WOLLONGONG CITY COUNCIL

# Traffic Committee Minutes of Meeting

14 November 2023

Item 2.2 - THIRROUL, Pass Avenue – Dividing Barrier Line

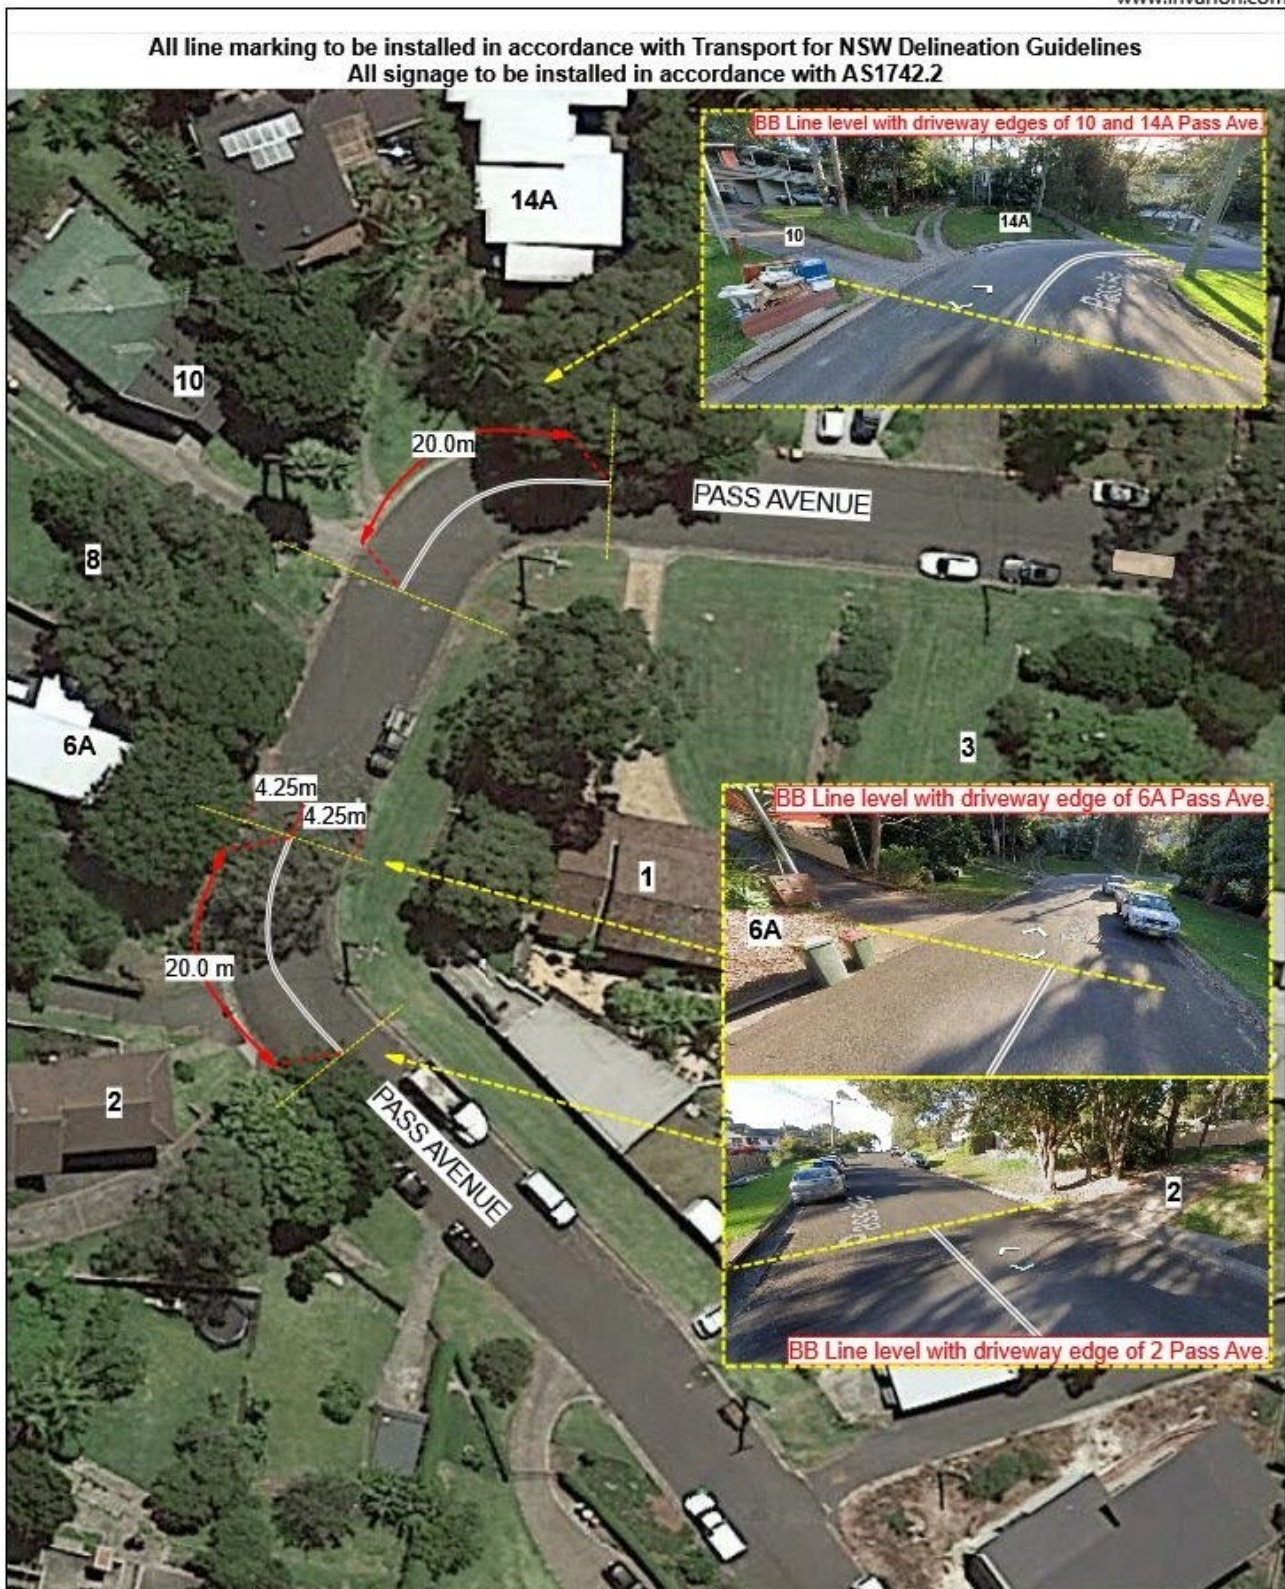
To improve road safety at this location, Council intends to install Dividing Barrier (BB) lines at the identified curves at Pass Avenue, Thirroul as per the attached plan. The proposal is expected to reduce the risks of head-on collisions between vehicles whilst improving sight distance on the bends.

Council reviewed the communities' concerns and have reduced the length of the BB lines (parking impact). On balance, Council believe that the proposed BB lines are unlikely to increase speed on the sharp bends noting parking will still be retained on approaches to the bends and the line will reduce the likelihood of vehicles cutting the corner (at higher speeds). It is deemed the proposal will achieve more positive road safety outcomes overall.

The attached plan be approved.

Item 2.3 – BULLI, Hospital Road – Timed Parking Restrictions, page 2 of 2

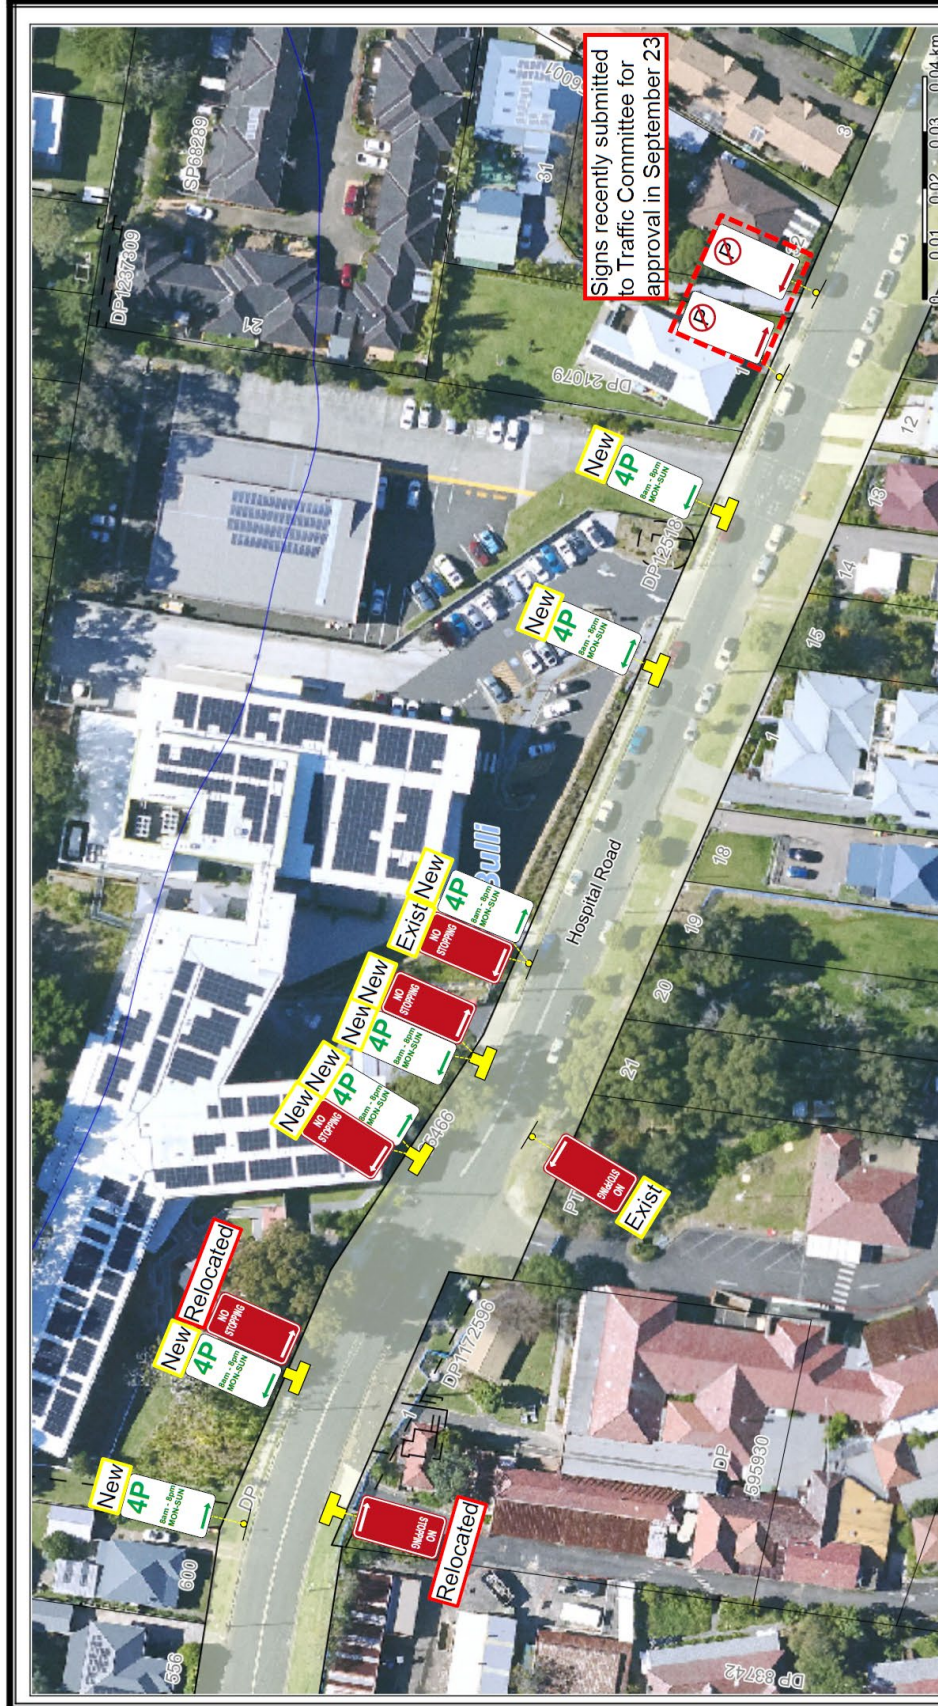
Council have received reports of parking concerns on Hospital Road, Bulli fronting the newly developed Bulli Hospital site. To address the concerns and increase parking turnover, Council is proposing the installation of 4-hour timed parking restrictions in the area and relocation of No Stopping zones in accordance with the attached plans. The relocation of No Stopping zones will maintain appropriate sight distance in accordance with Technical Direction for Pedestrian Refuges (TDT2011/01a).

Please note that the proposal will also remove a small section of asphalt which was installed during the COVID pandemic for residents to access the hospital. This is illustrated on page 1 of 2 of the attached plans.

Council approves the installation of 4-hour timed parking restrictions and No Stopping changes on Hospital Road, Bulli as shown in the attached plan subject to:

1. Additional consultation/notification being undertaken with the Hospital (for feedback on the proposed No Stopping modifications and asphalt kerb ramp removal).
2. The proposed 4-hour timed parking restrictions be timed from 8am-8pm to align with Hospital visiting hours.
3. The proposed 4-hour timed parking restrictions are amended to ensure the restrictions are only placed directly in front of the hospital site (rather than fronting residents' private property).

Item 2.4 – WOONONA, Campbell Street – Signage and Linemarking

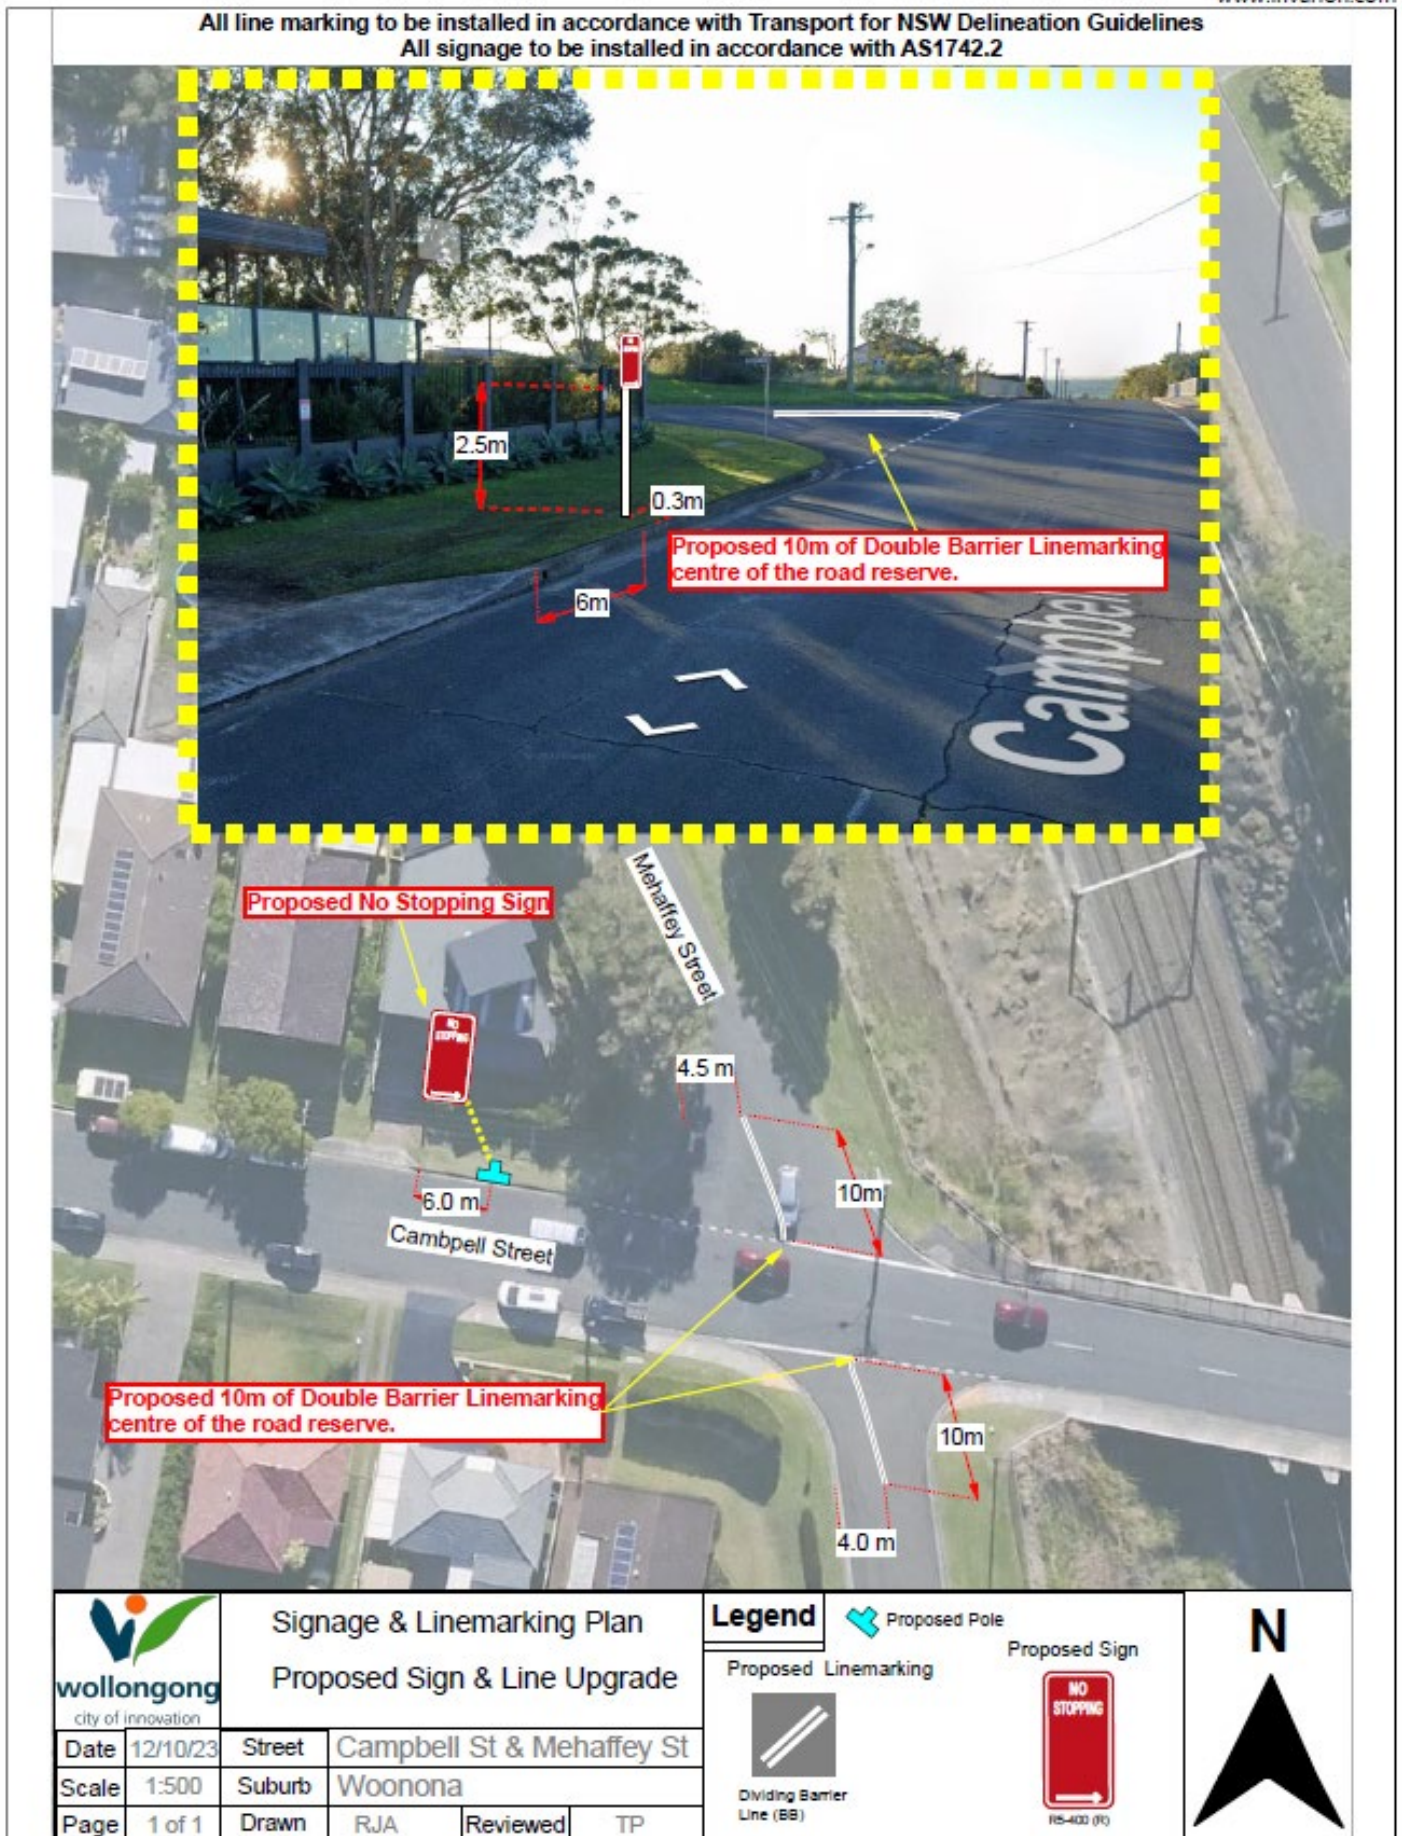
Council has recently received reports of near misses at the intersection of Campbell Street and Mehaffey Street, Woonona as a result of poor sight distance when vehicles are parking near the intersection.

To reduce the potential for collisions at the intersection, Council is proposing to install a 'No Stopping' sign to introduce parking restrictions greater than restrictions in accordance with NSW Road Rule 170. The installation is expected to improve sight distance noting that the approach to the intersection is a non-standard geometry. Dividing barrier (BB) linemarking is also proposed on Mehaffey Avenue (both approaches to Campbell Street) to assist with vehicle positioning when approaching the intersection.

The attached plan be approved.
